# Community Tot-Lot

## Town of Westwood ADA Transition Plan

June 2023

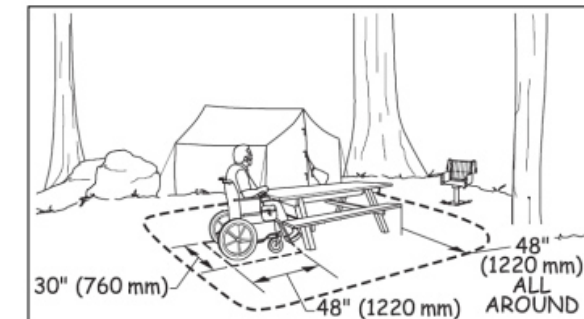
- Recommend providing a 36" by 48" min. stable, firm and slip-resistant area alongside at least one bench in each distinct area where benches are provided so that a person using a wheelchair or other mobility device is able to sit alongside someone seated on the bench with their shoulders aligned. See the following illustration for best practice recommendations for benches:
